ADDRESS: 1723 MEMORIAL AVE

Proposal: Construct three-story building with pilot house

Review Requested: Review and Comment

District Designation: Parkside Historic District, Non-contributing, 12/11/2009

Drawing Name:
SECTIONS. ELEVATIONS.

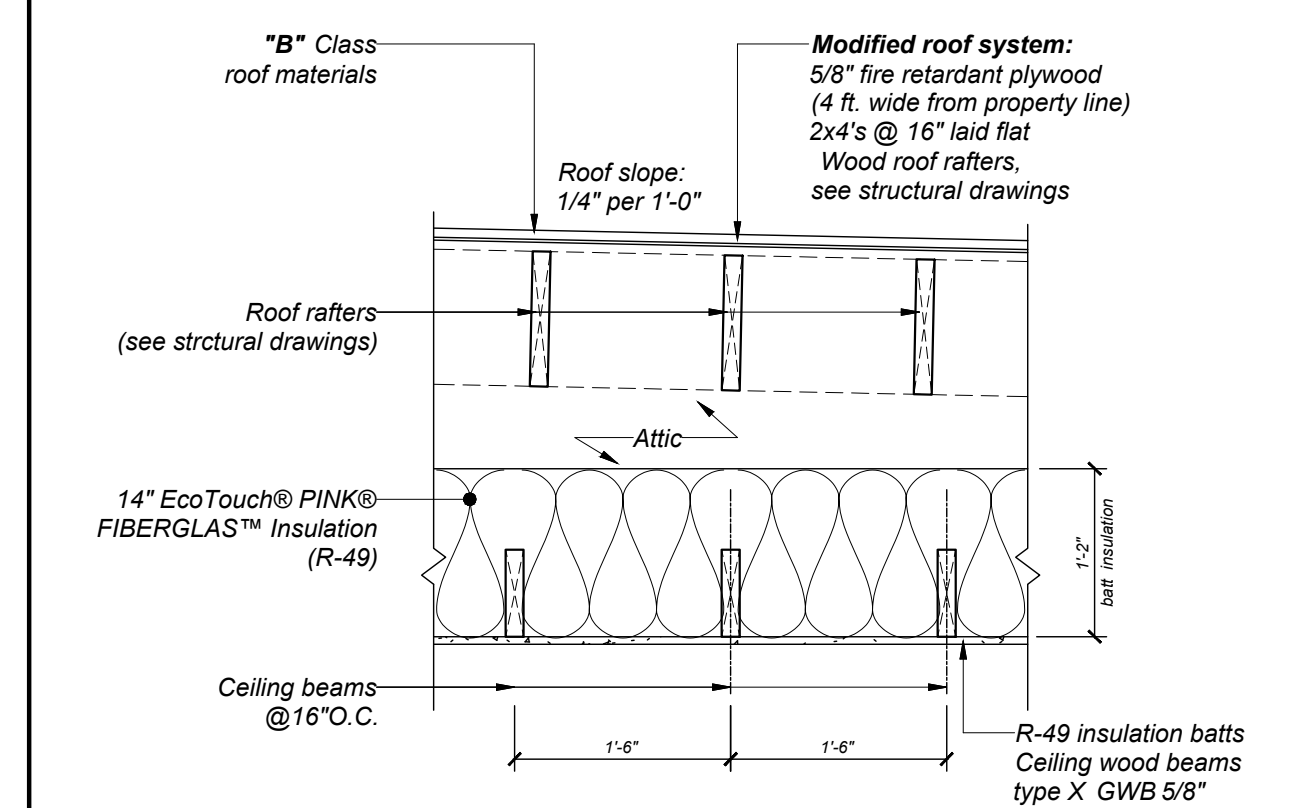
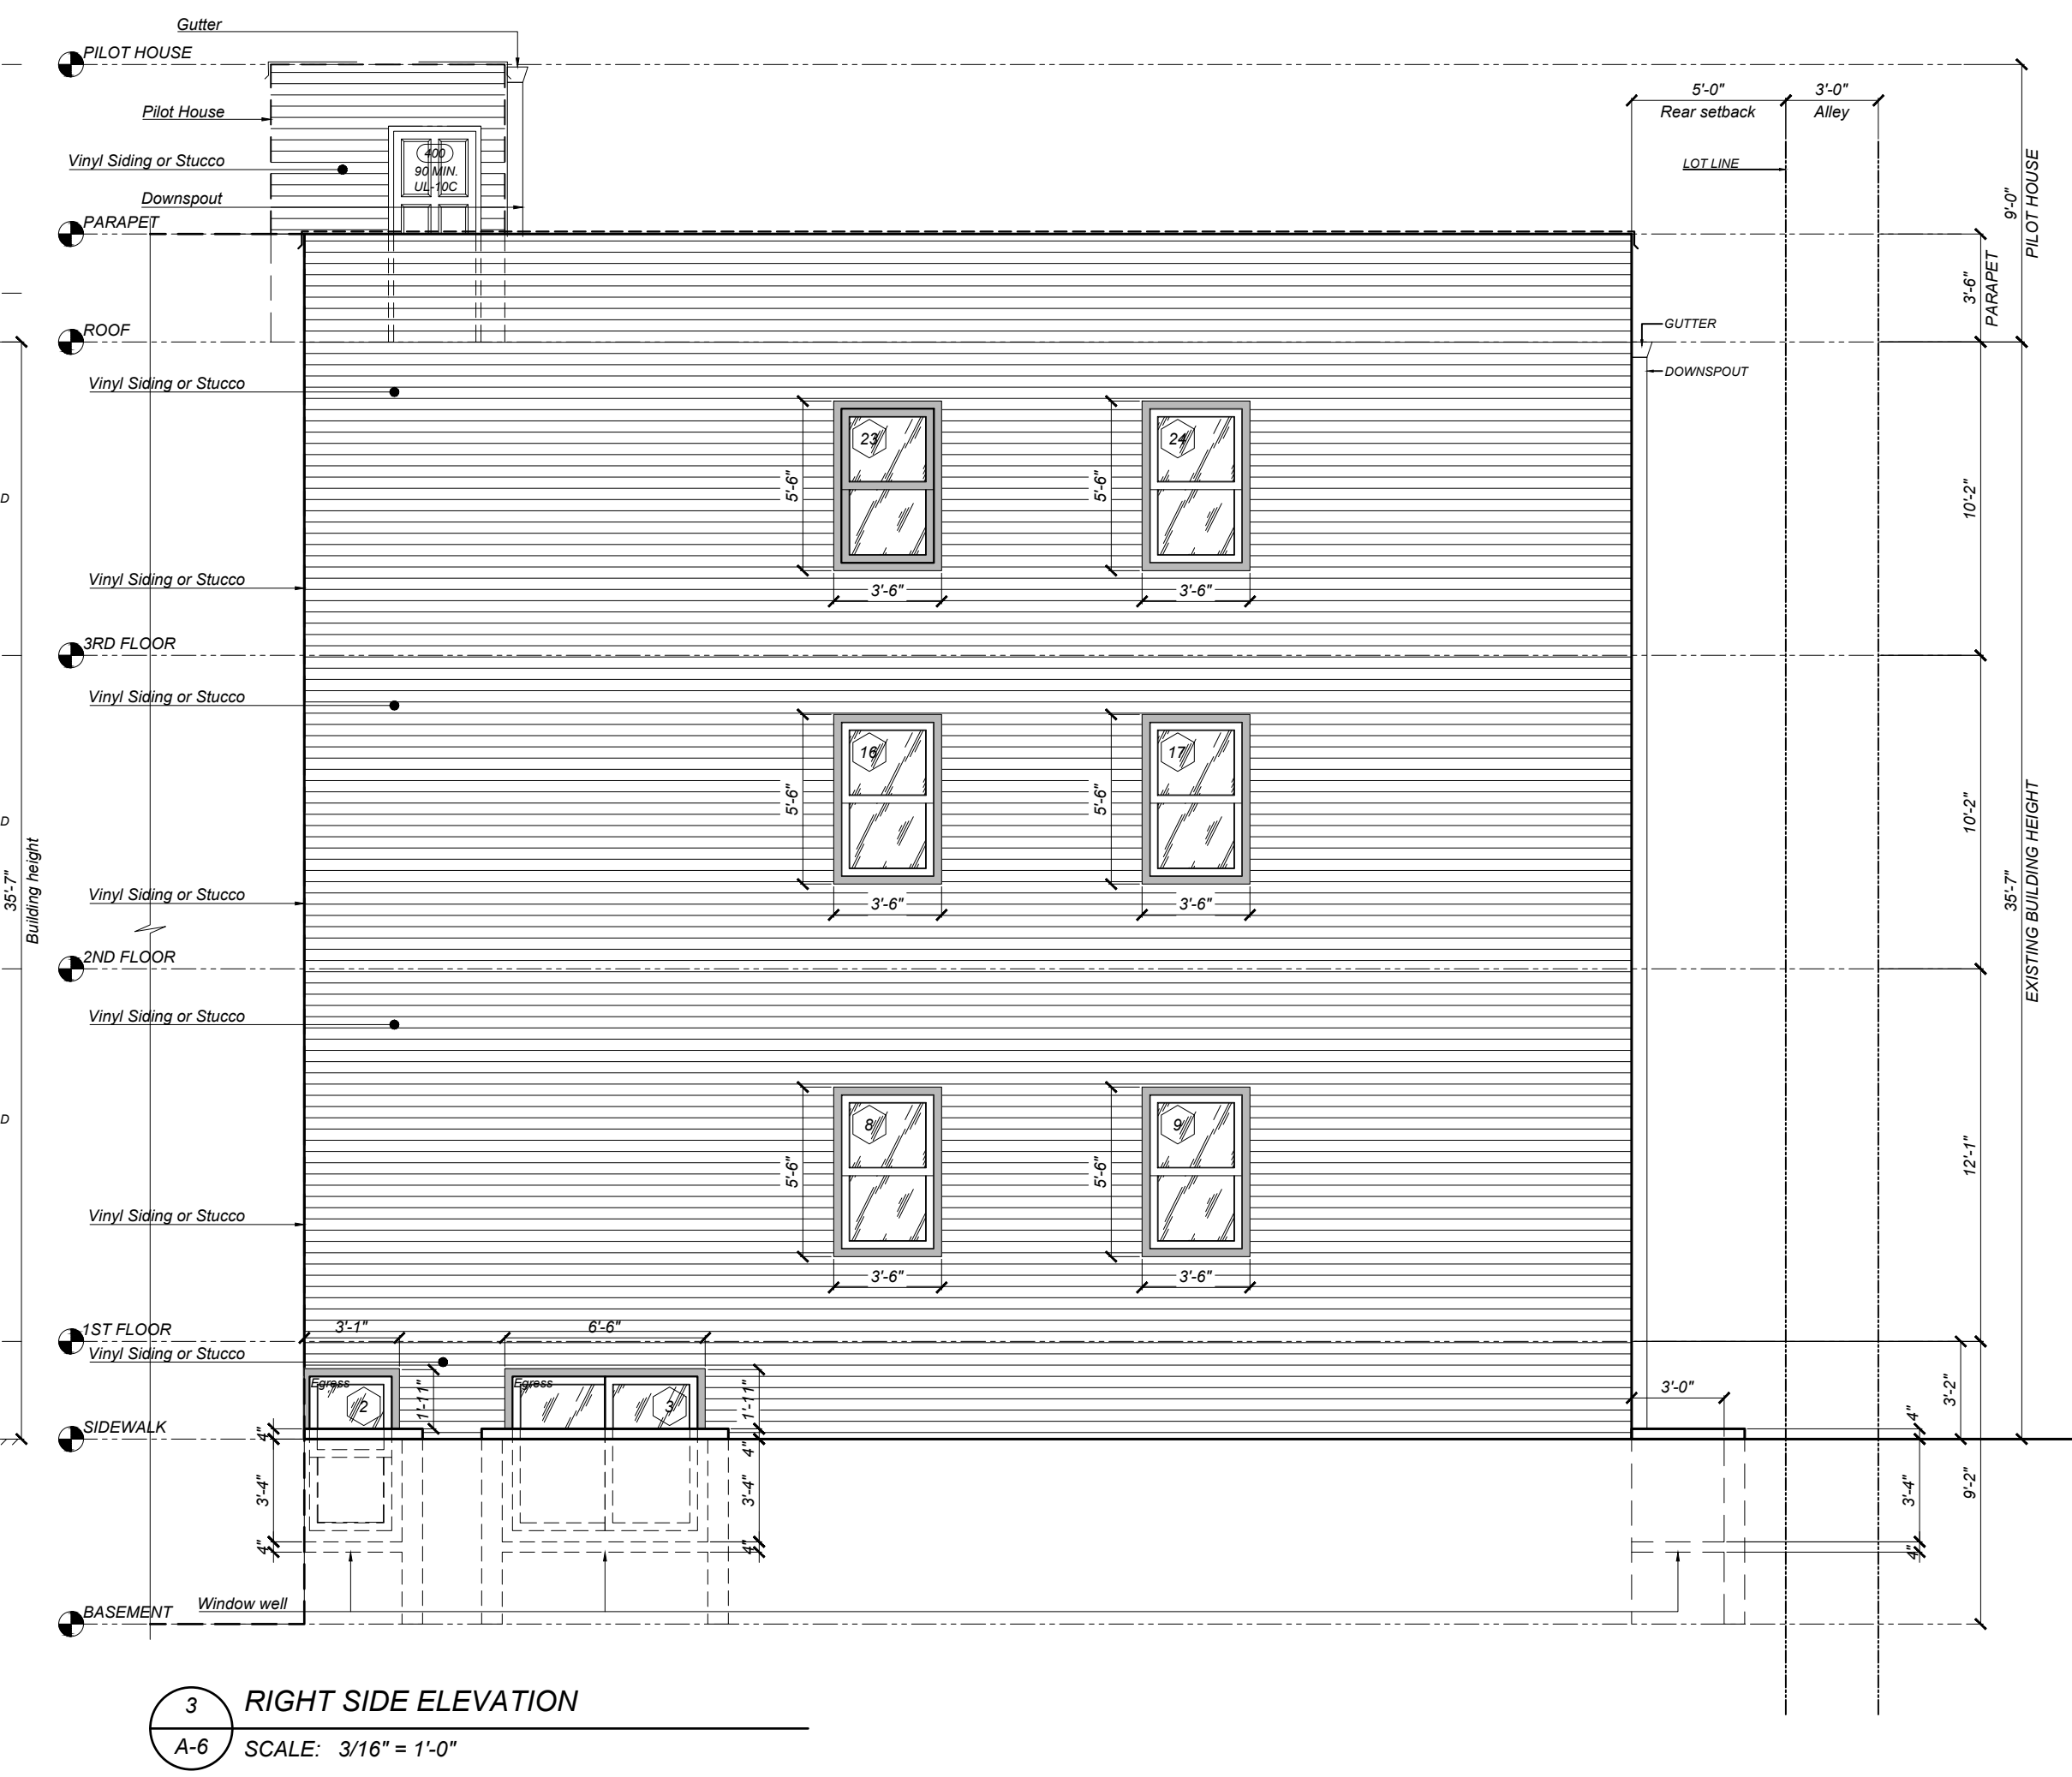
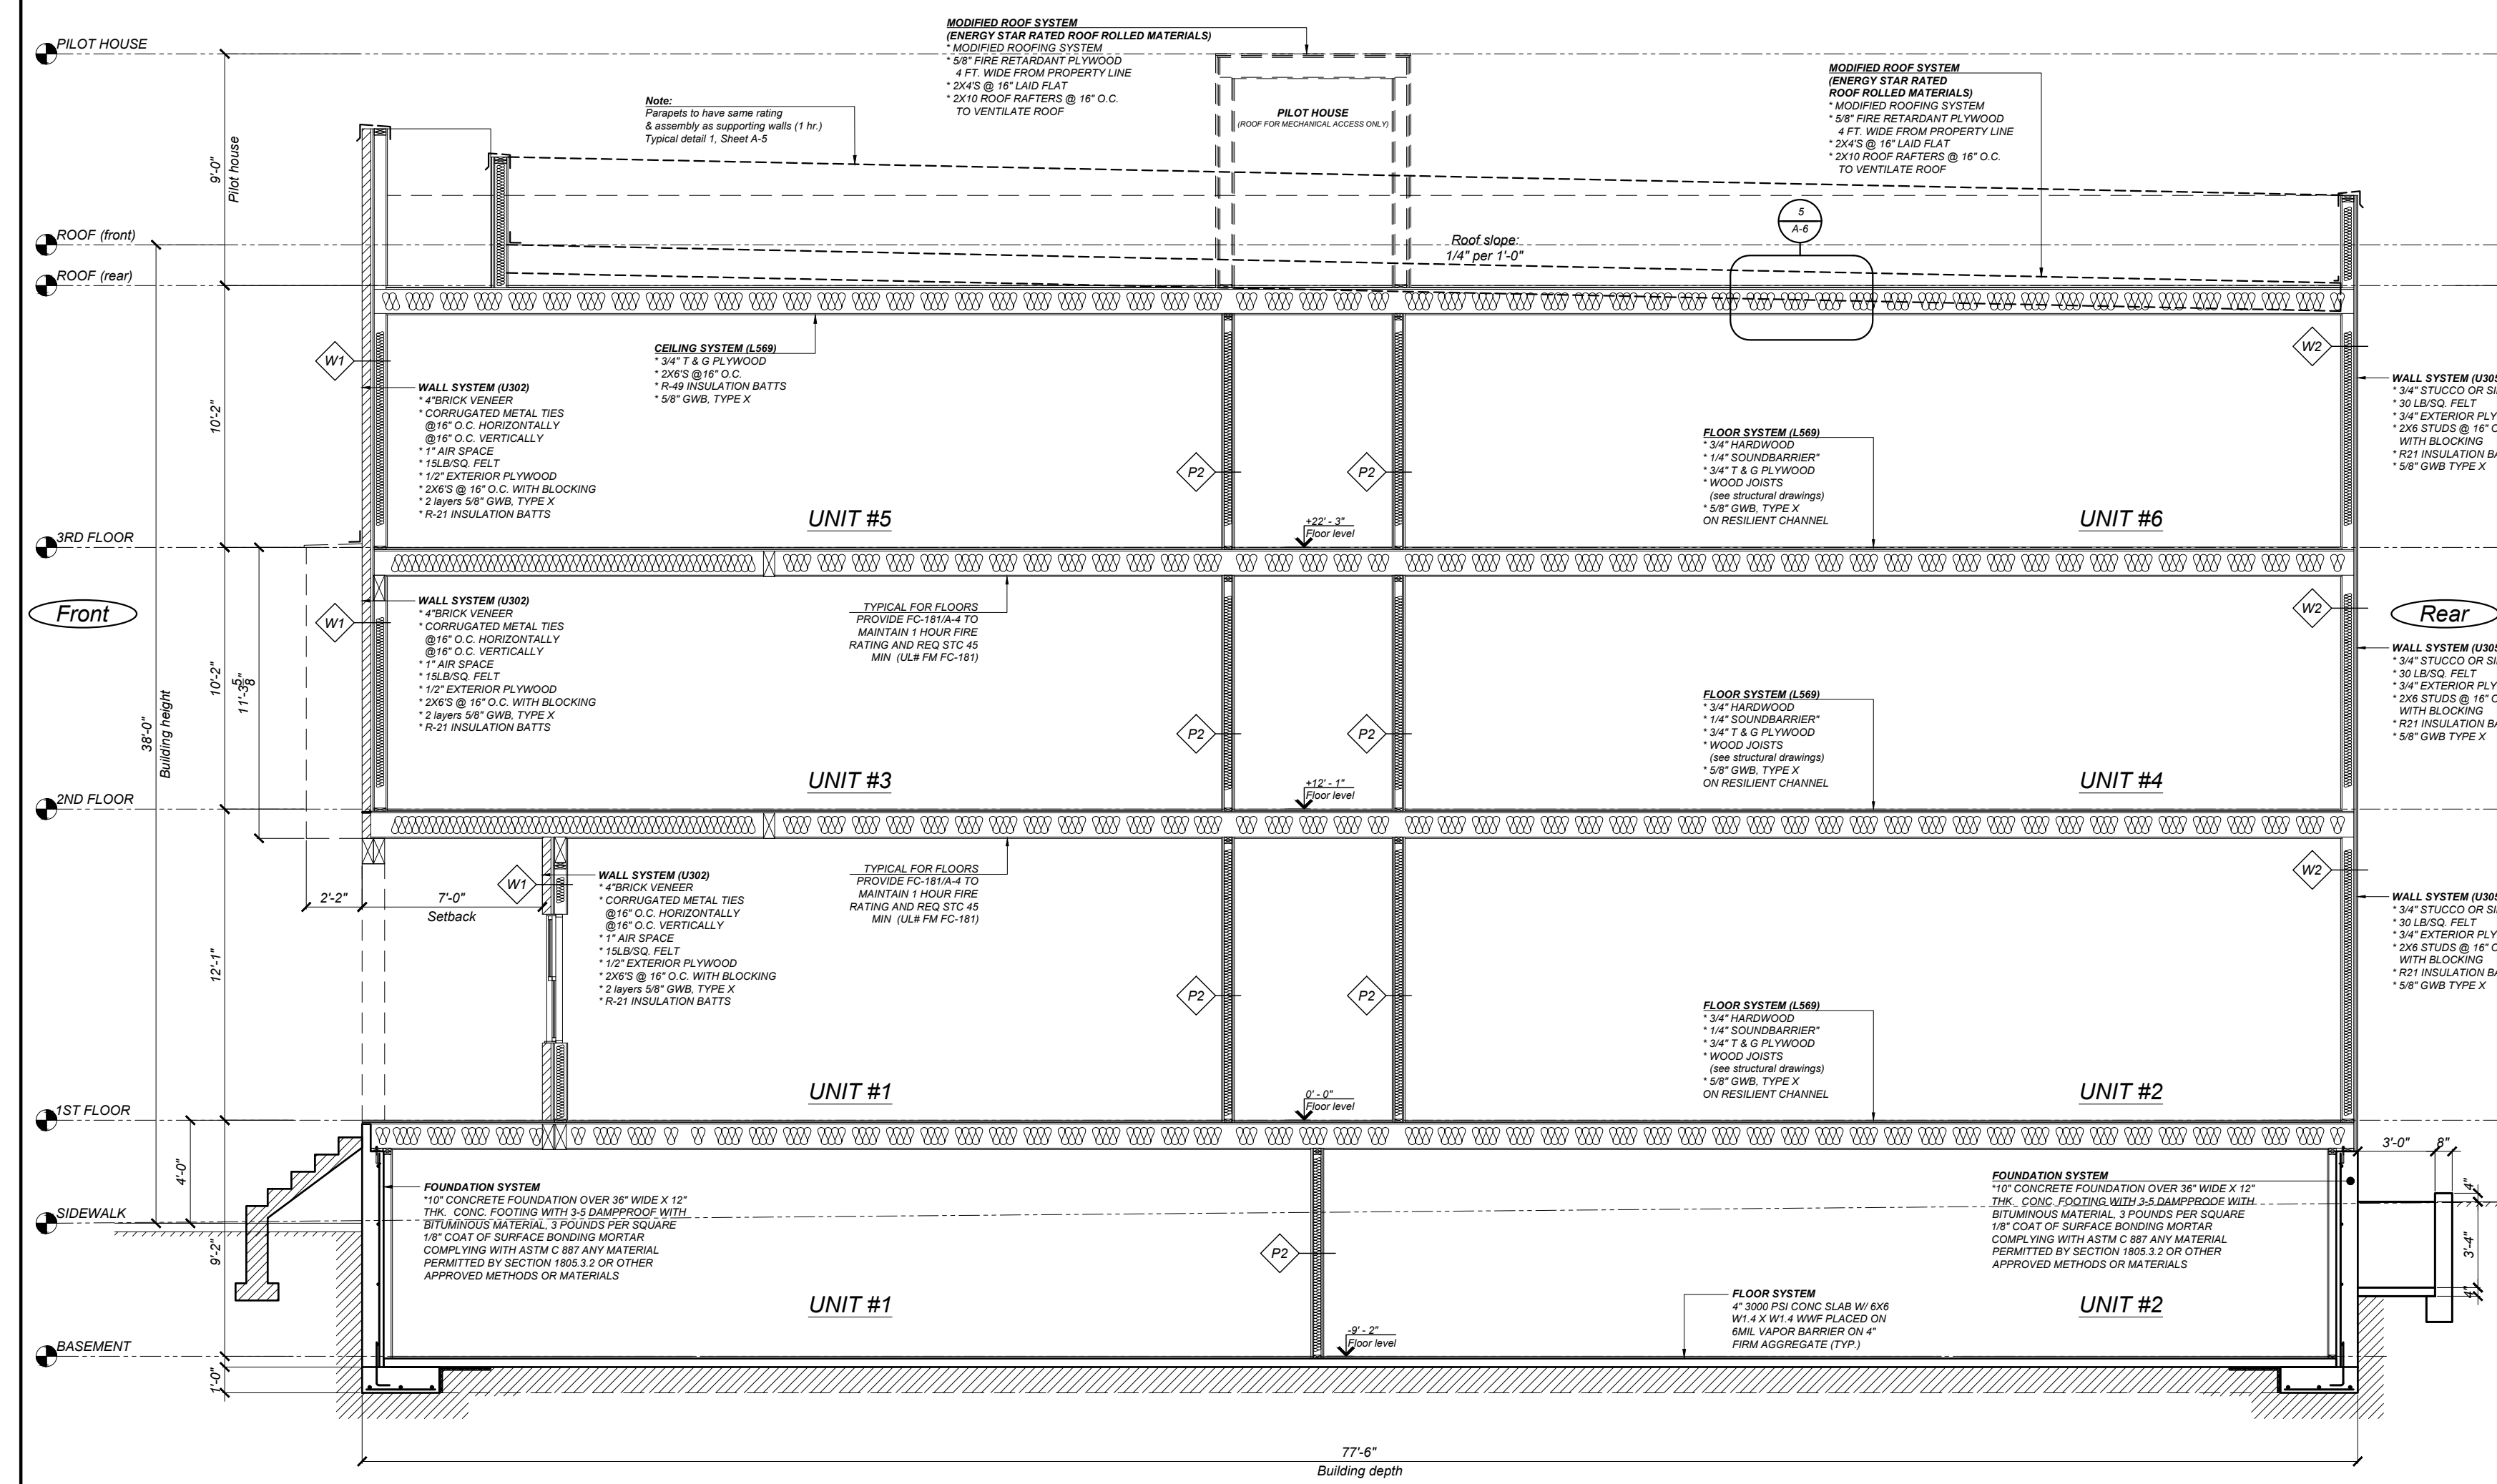
- Generally speaking, the design of the proposed new construction project reflects the size, scale, proportion and massing of the architecture of the Parkside Historic District. The proposed materials, however, do not. Vinyl siding or stucco is proposed for the prominent bay window at the front façade, and vinyl windows are proposed throughout. A brick veneer is proposed for the front façade; however, it would be helpful to know if the intent is to match the thin, tan-colored brick that is seen throughout the district. The front windows at the third story are square-topped rather than curved like the majority of the houses on the block, and no decorative brick mold is proposed. The front façade also lacks the circular window at the top which is another design feature seen at most of the other houses in the row.

STAFF COMMENT: The proposed design is generally compatible with the historic district, but the windows at the front façade should be aluminum-clad or composite rather than vinyl; Hardi-board siding should be used rather than vinyl siding; the brick veneer should match the tan brick seen throughout the district; the windows at the third story should be curved; and decorative brick window surrounds should be added to the design of the front façade, pursuant to Standards 9 and 10.
